SECTION 009113 – ADDENDUM TWO

- A. Project Name: 22034.02 Meridian High School
- B. Owner: Meridian Public School District, 1019 25th Avenue, Meridian, MS 38391
- C. Architect: Dale | Bailey, an Association, One Jackson Place, Suite 250, 188 East Capitol Street, Jackson, MS 39201-2100
- D. Architect Project Number: 22034.02
- E. Date of Addendum Two: 7 September 2023

A-102a

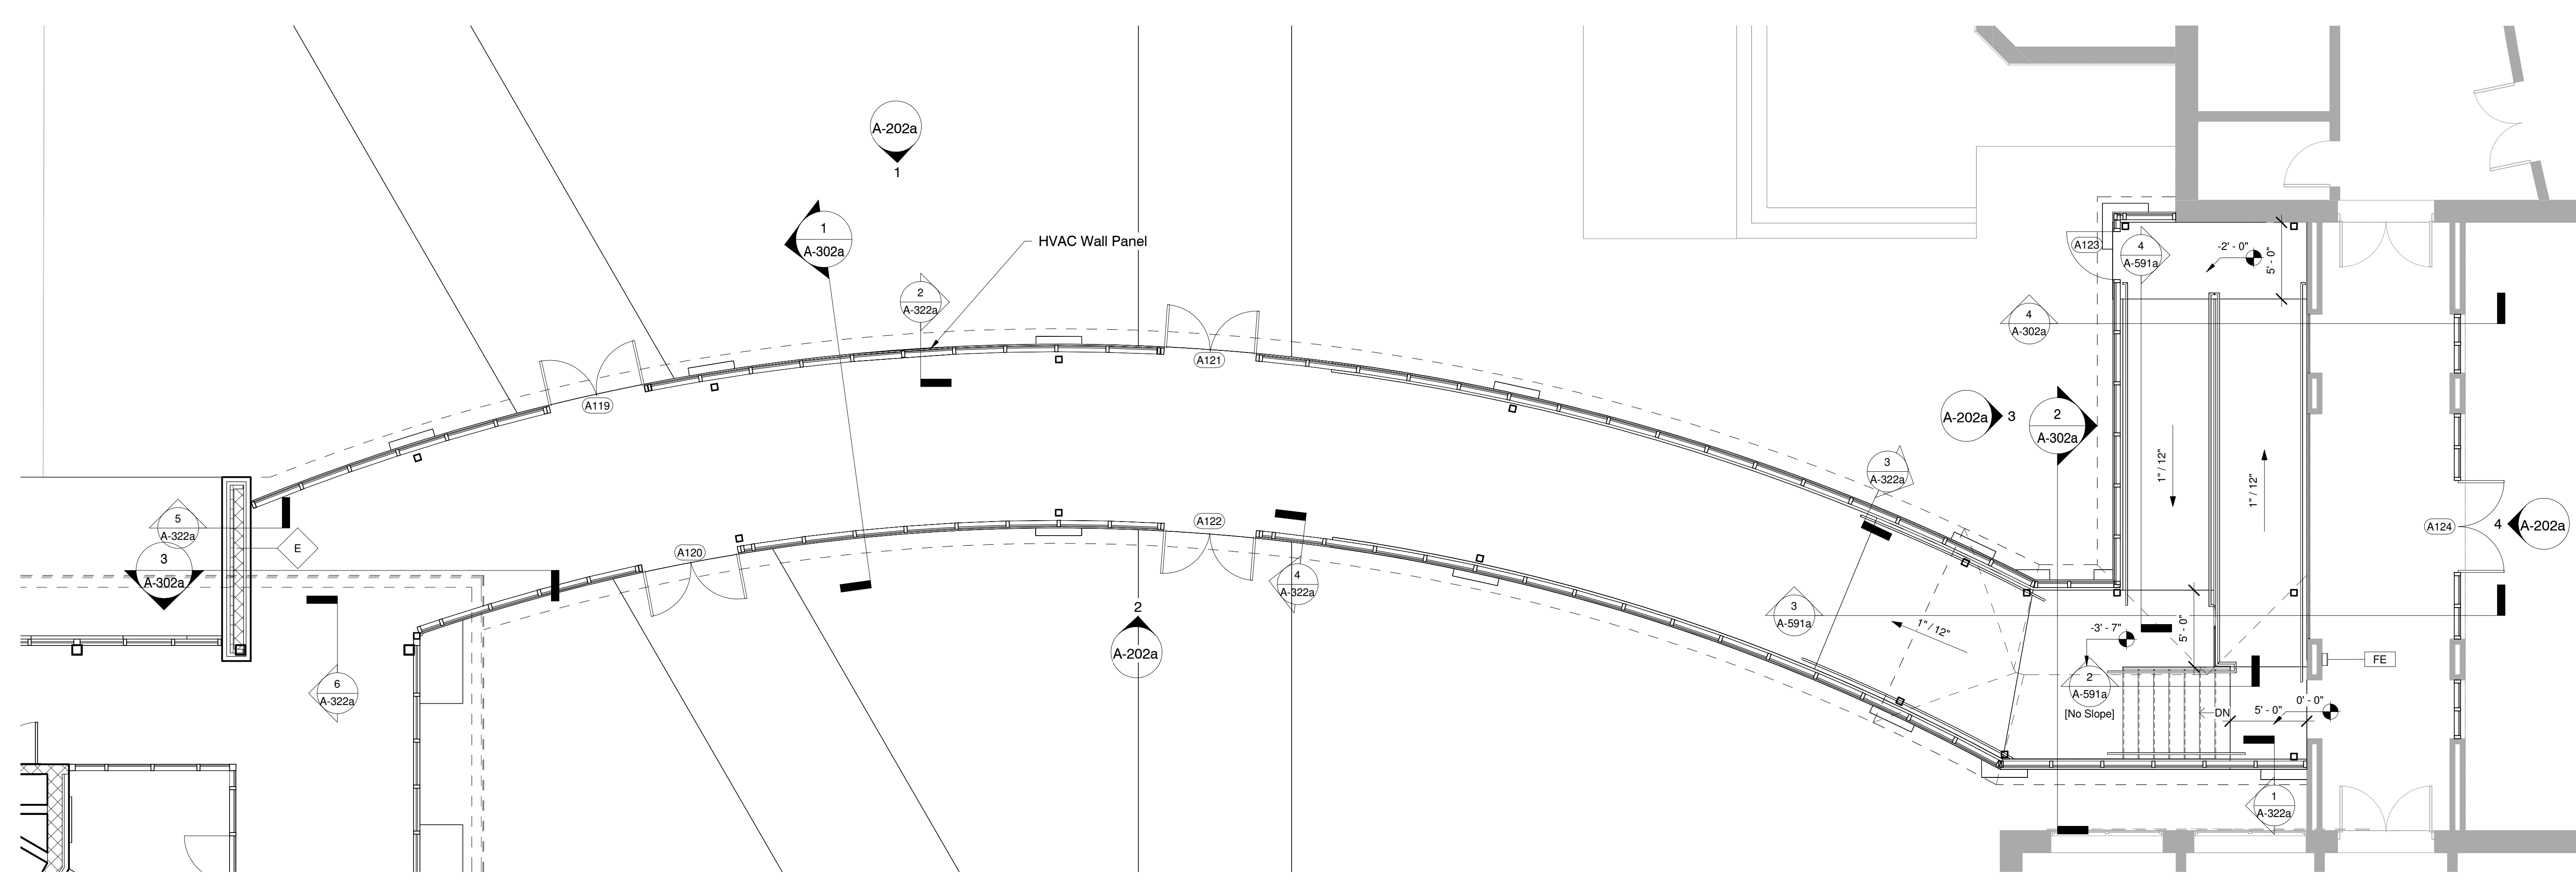
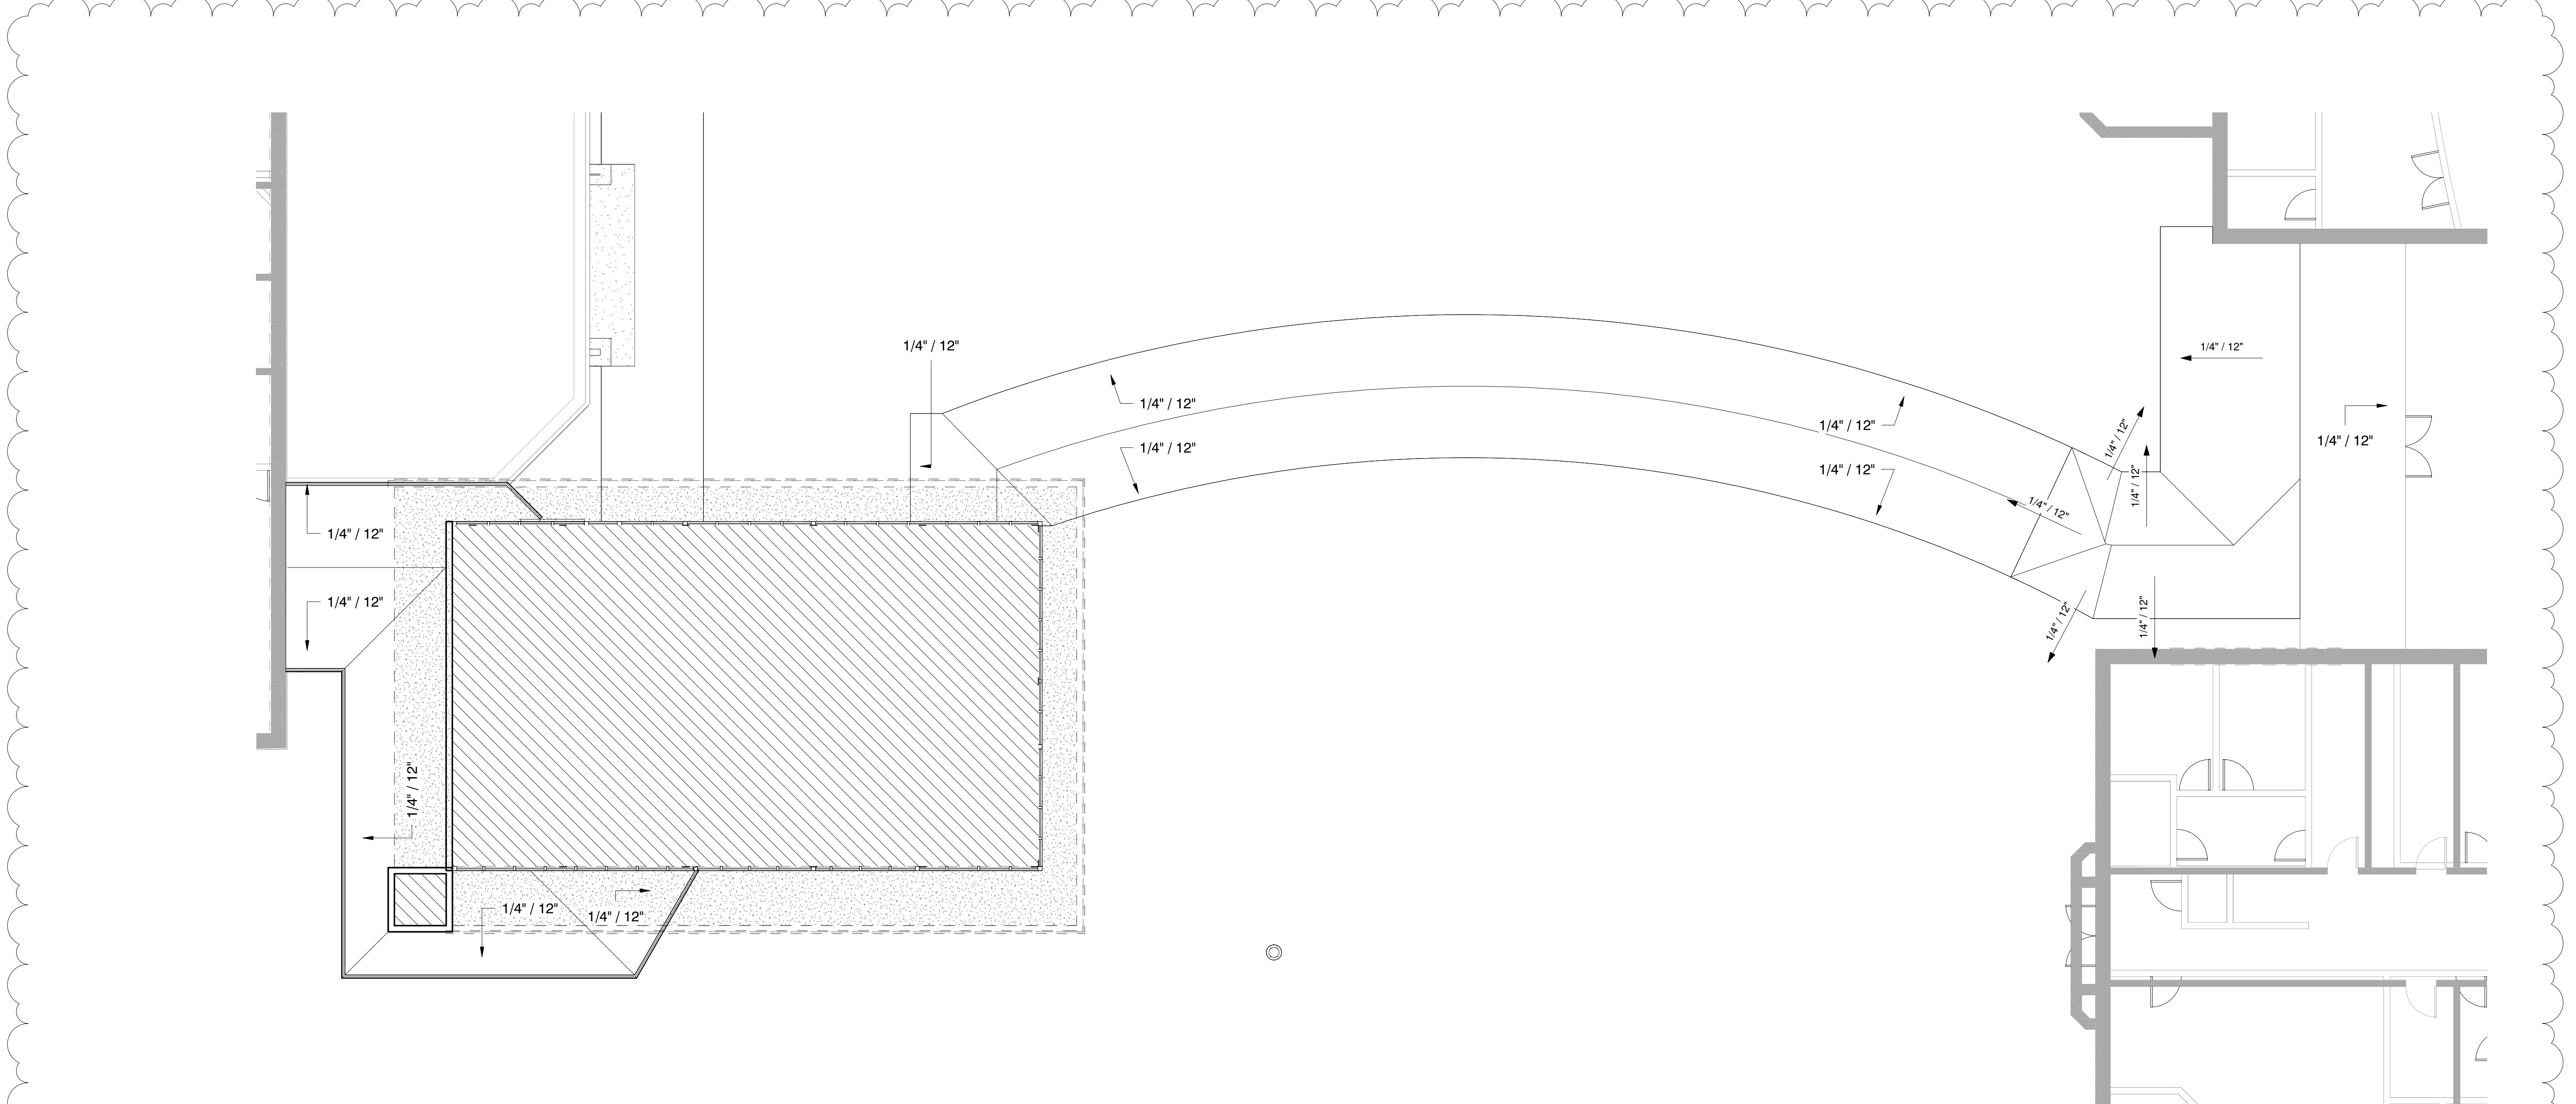
J. QUESTION: Please provide a Roof Plan for the Corridor.

- F. Sheet A-102a – Administration Floor Plans. (Revised). Delete this sheet in its entirety and replace it with attached. Added roof plan for corridor and the roof at admin.

ANSWER: See attached revised A-102a sheet.

8 SF8
3/8" = 1'-0"

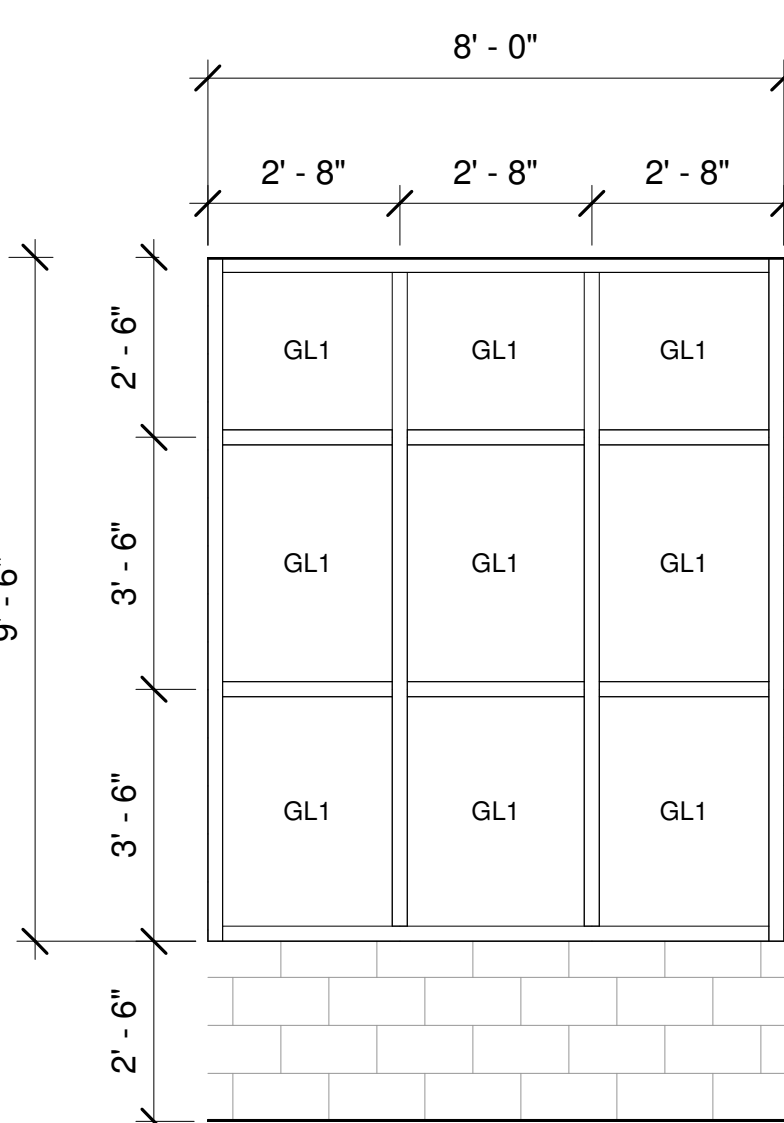
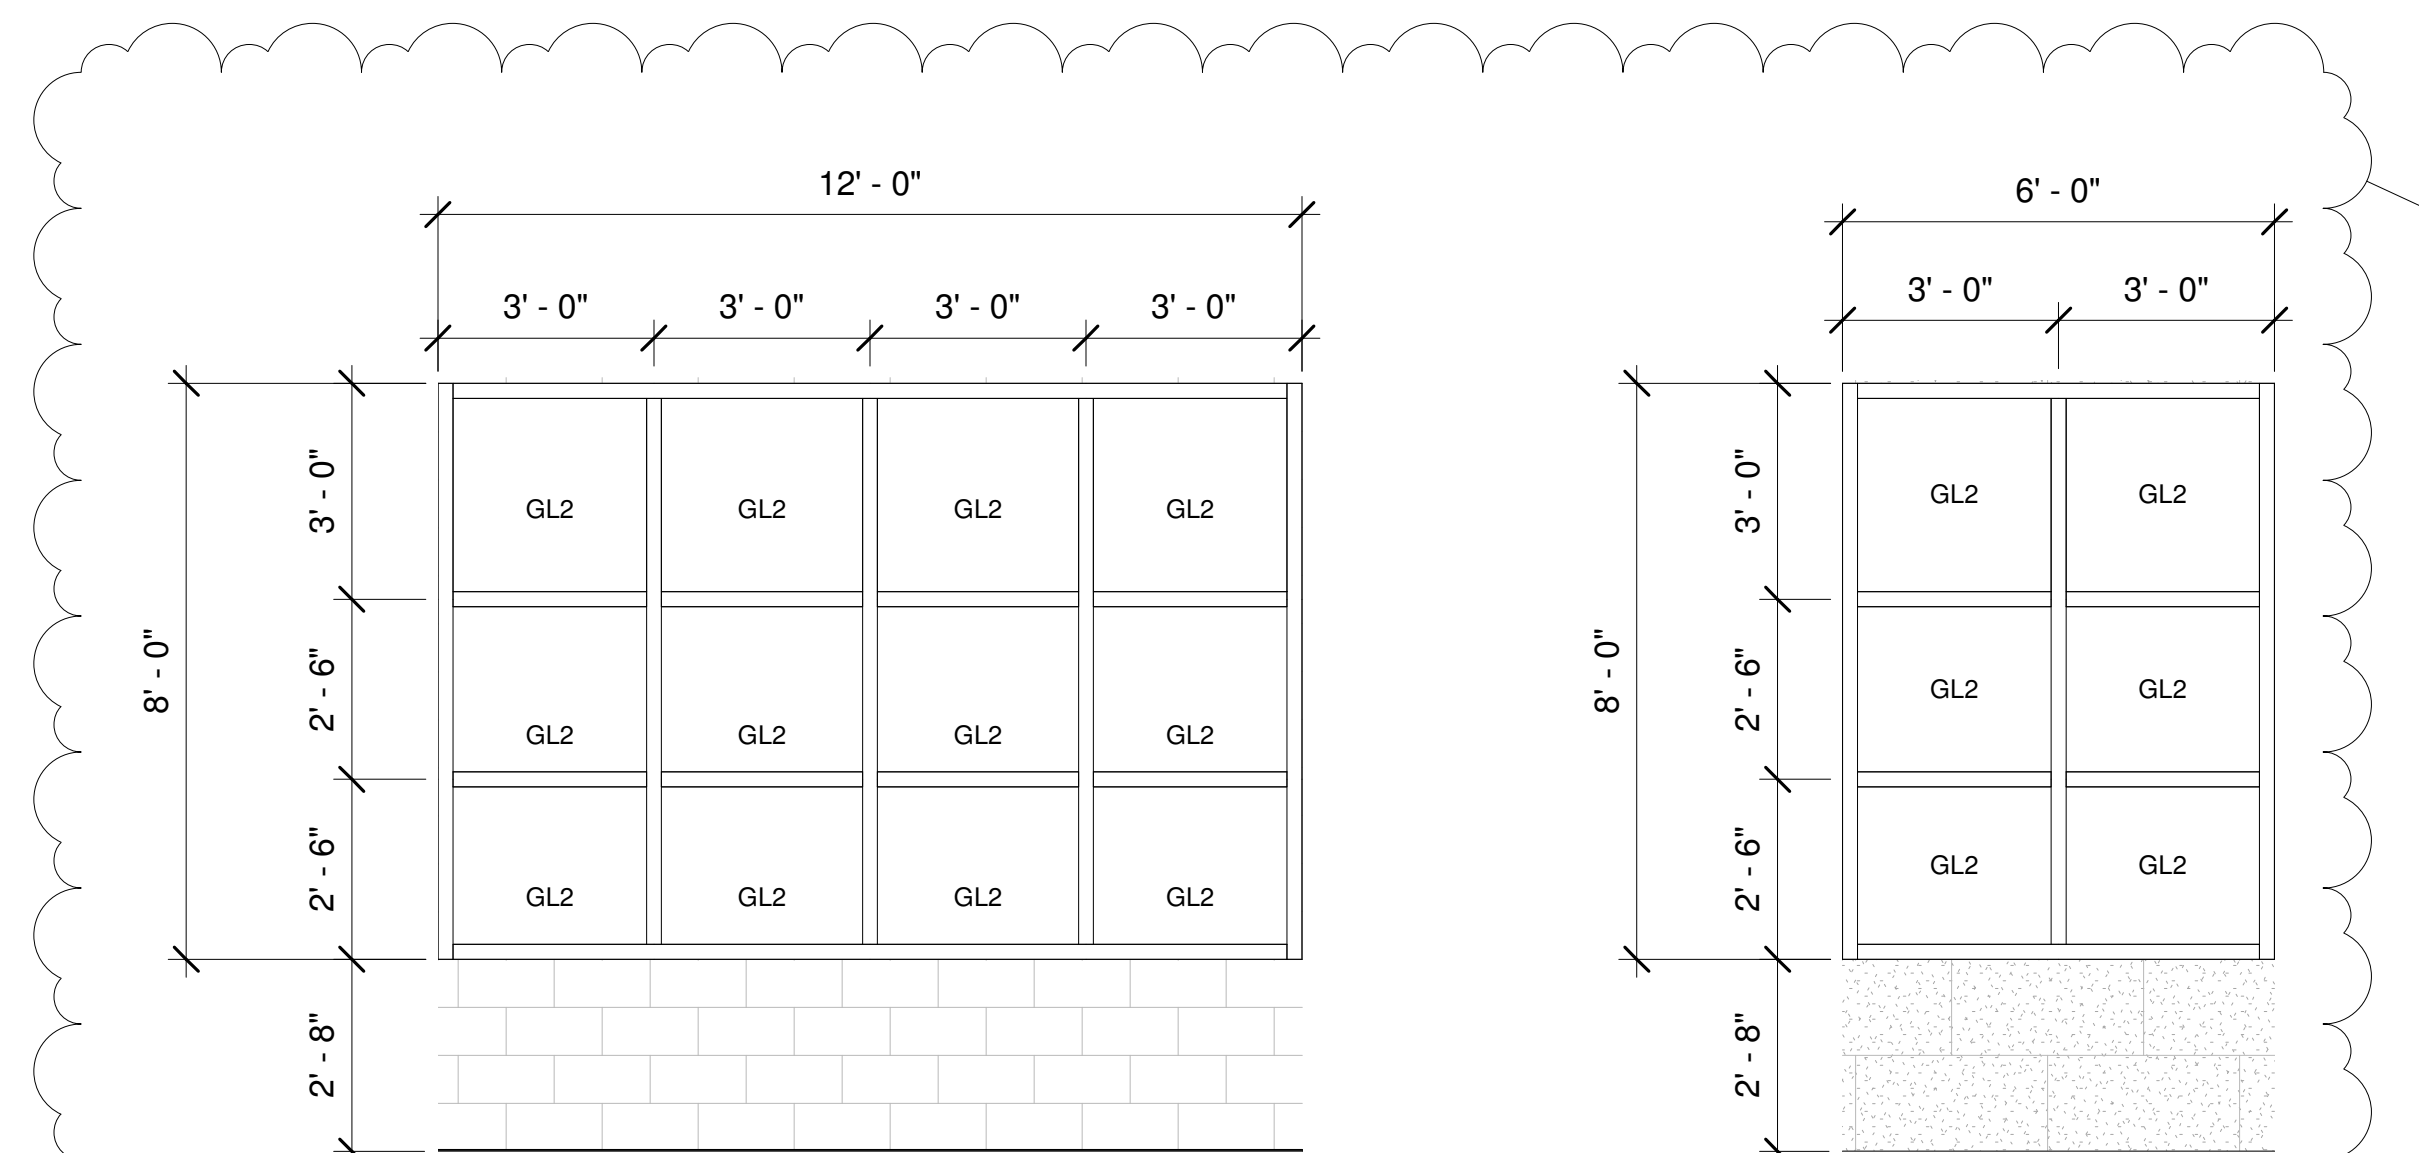
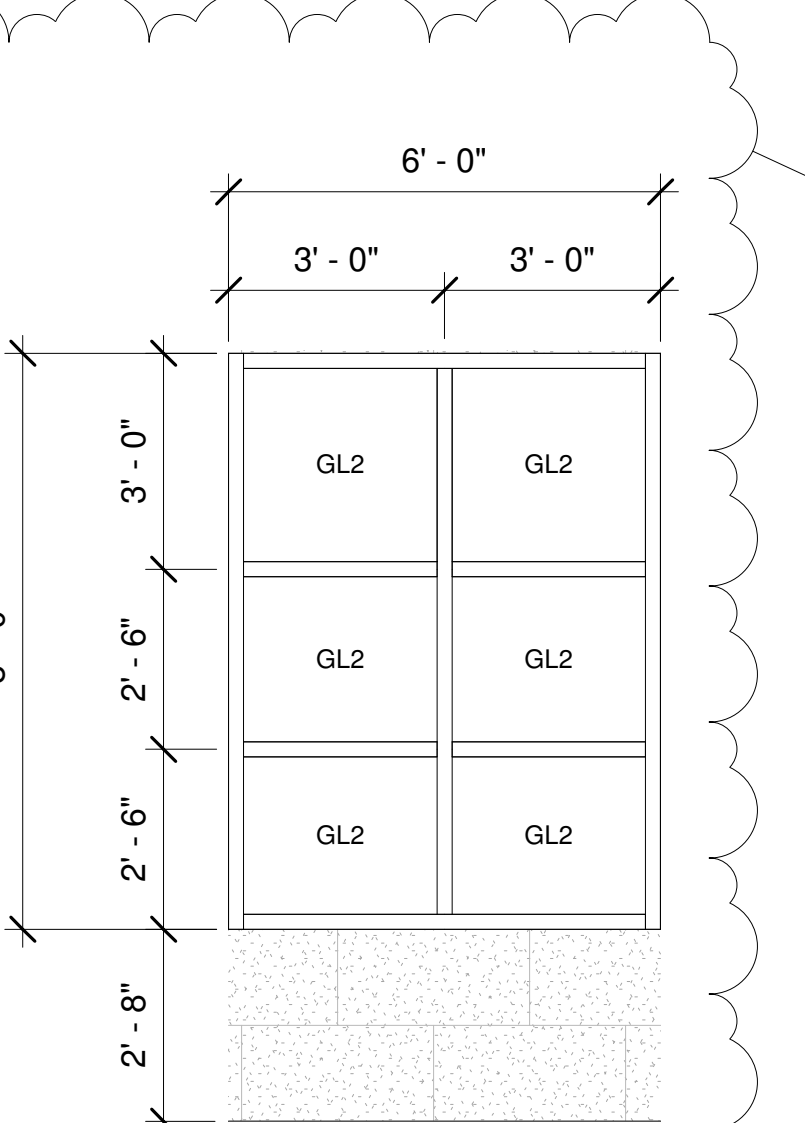
R. QUESTION: A-521 elevation 8 & 9: The frame heights are incomplete. What is the total height of these frames?

- H. Sheet A-521a – Storefront and Window. (Revised). Delete this sheet in its entirety and replace it with attached. Added dimensions for curtain.

ANSWER: See attached updated drawing.
